Staff Report

To: Salt Lake City Historic Landmark Commission
From: Lex Traughber – Senior Planner
(801) 535-6184 or lex.traughber@slcgov.com
Preston Larson – Planning Intern
Date: March 1, 2018
Re: Petition PLNHLC2017-00941, 690 N. West Capitol Street – New Construction
Petition PLNHLC2018-00096 - 690 N. West Capitol Street – Special Exception

NEW CONSTRUCTION IN A HISTORIC DISTRICT

STERLING ON CAPITOL HILL

EXISTING BLOCK FACE HEIGHT ANALYSIS

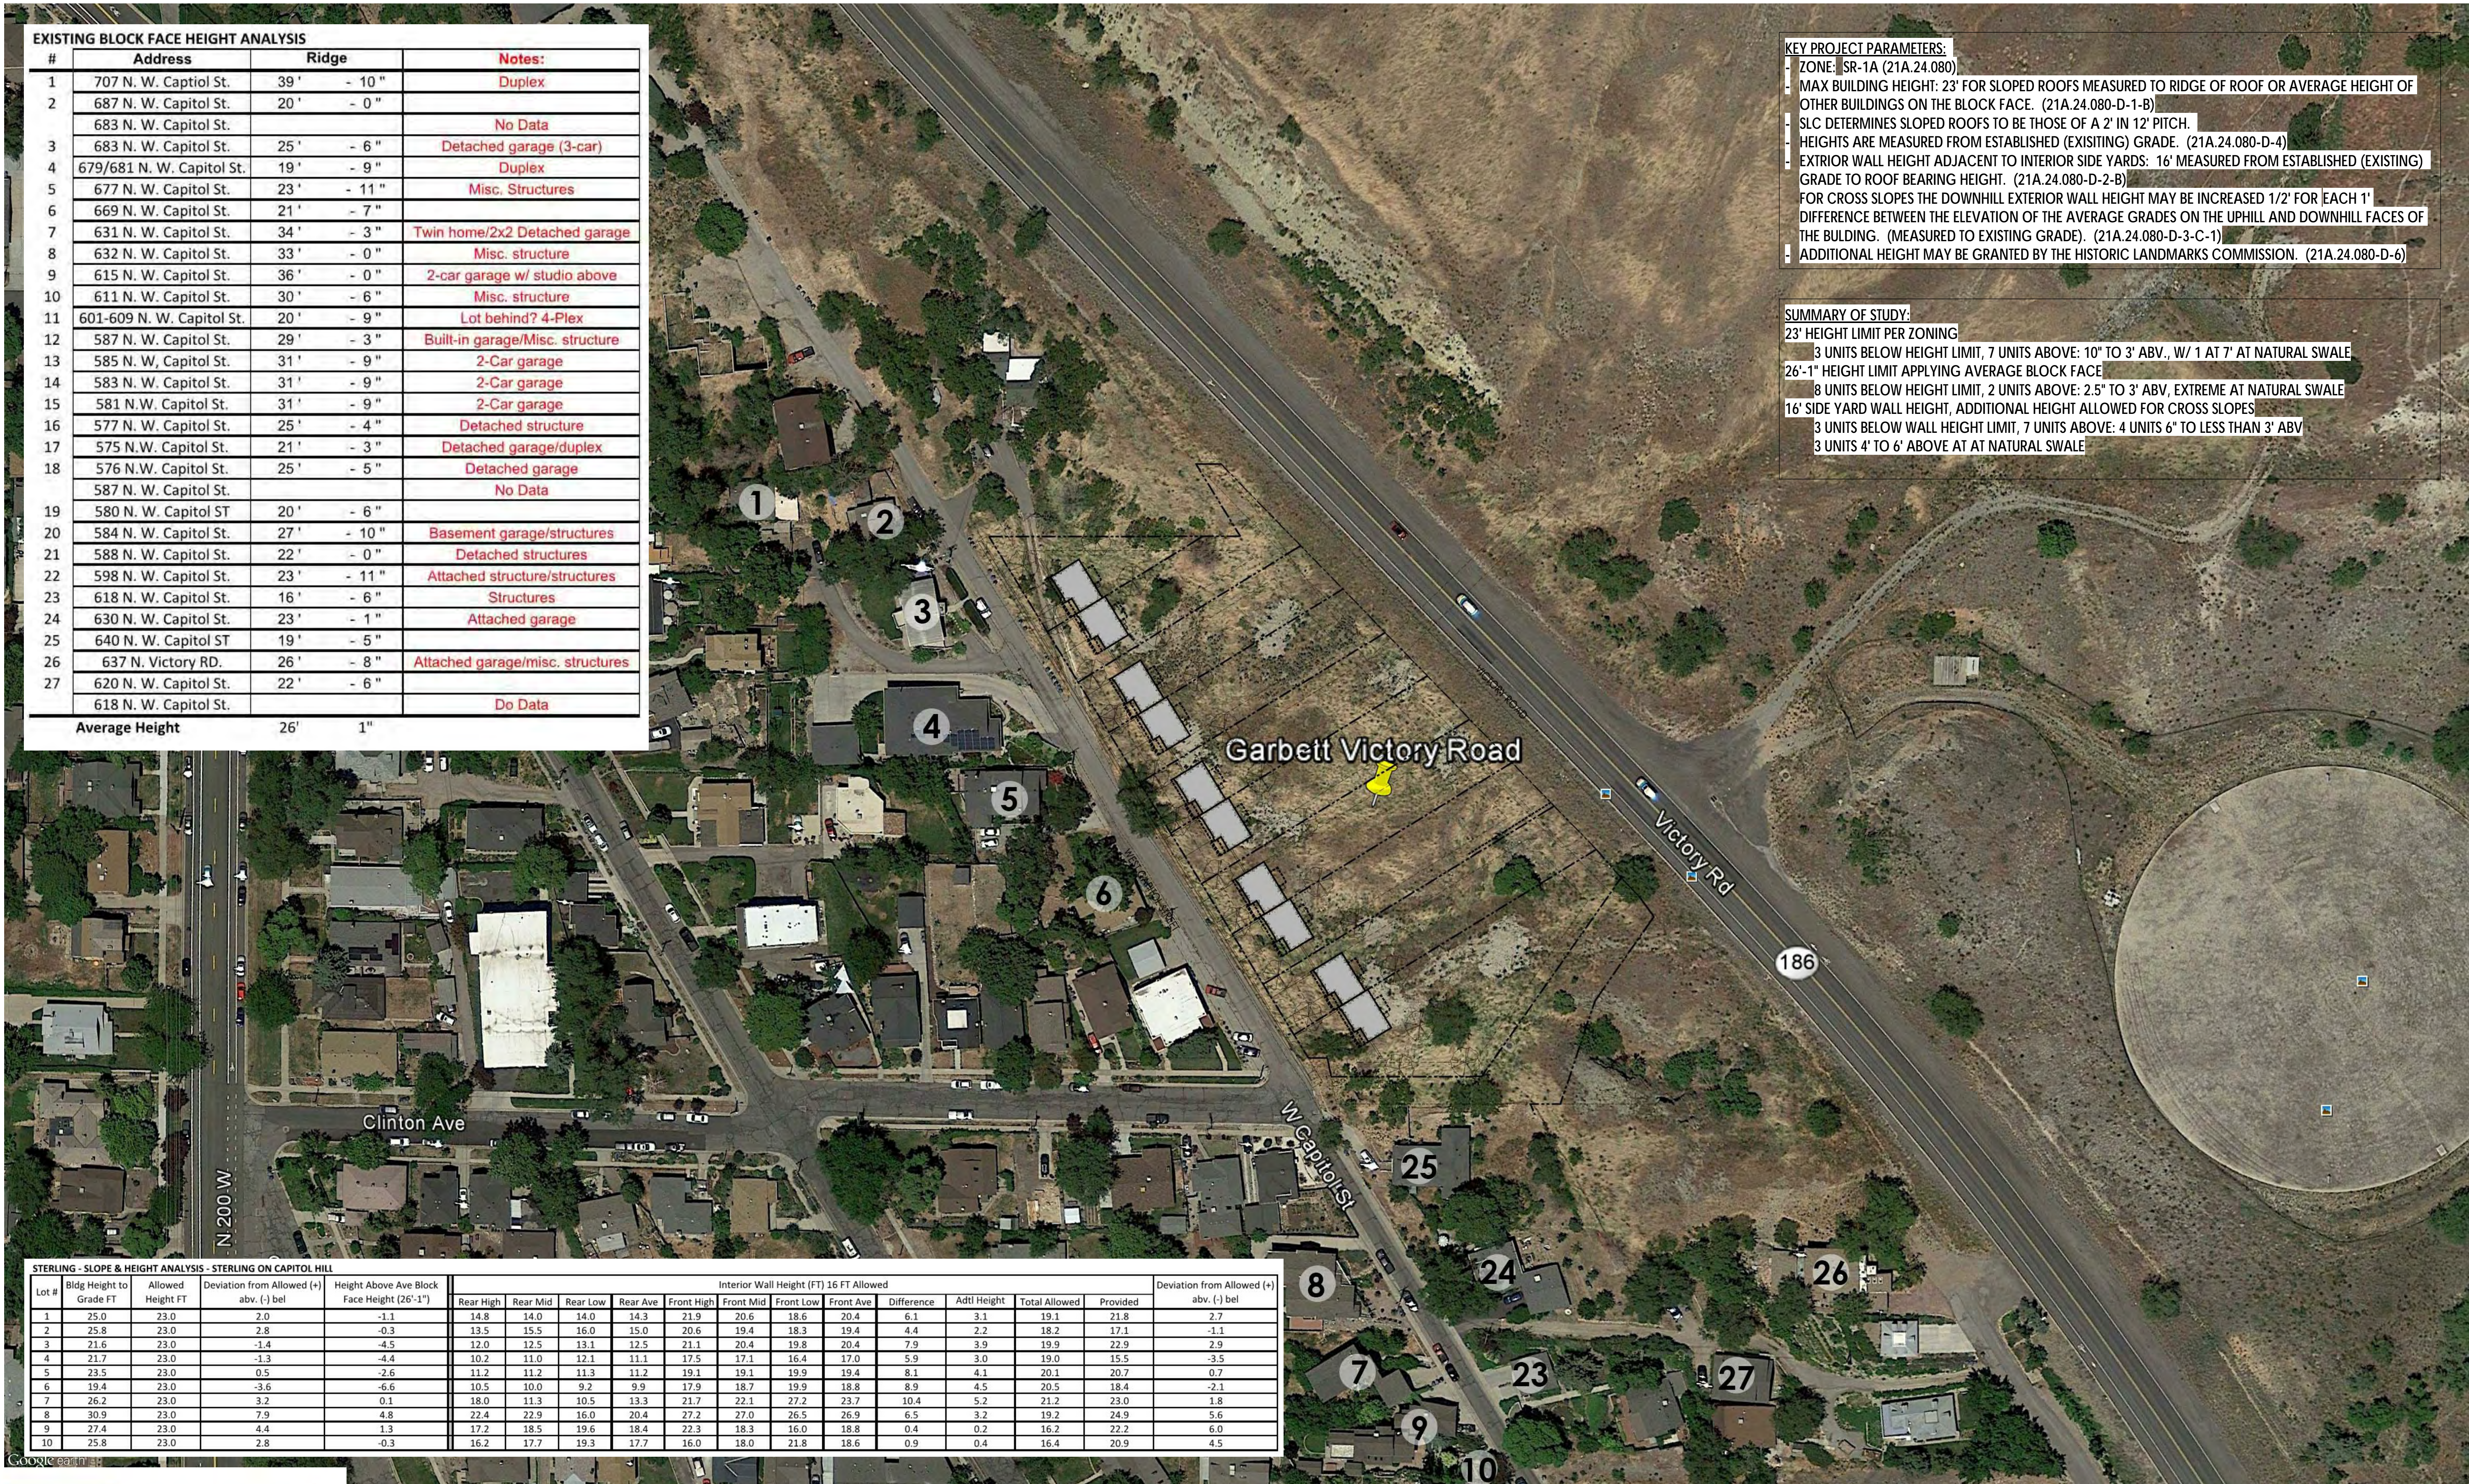
1. Accept the average block face height of **26'-1"** to be used as the height limit for this property. This will allow all but three (3) units to meet building height. Staff notes that a building height study was conducted along West Capitol Street in 2007 as part of a previous proposal for the subject property. The summary of the study is included as an attachment and shows that the

average building height along N. West Capitol Street was/is 26'1". This summary is included for reference as Attachment E – Building Height Study.

2. For the three (3) units that exceed the average block face height, the applicant requests that **average block face building height be flexible and modified by up to five feet (5') to allow for** accommodation of cases where extreme cross slopes exist. The applicant asserts that this accommodation will provide better transition between the buildings along the street face to maintain a more consistent relation to the street. The three units in question are those on proposed Lots 7-9. Please see the Height/Slope Study page D102 included in the attached plans – Exhibit C – Development Plan Set.
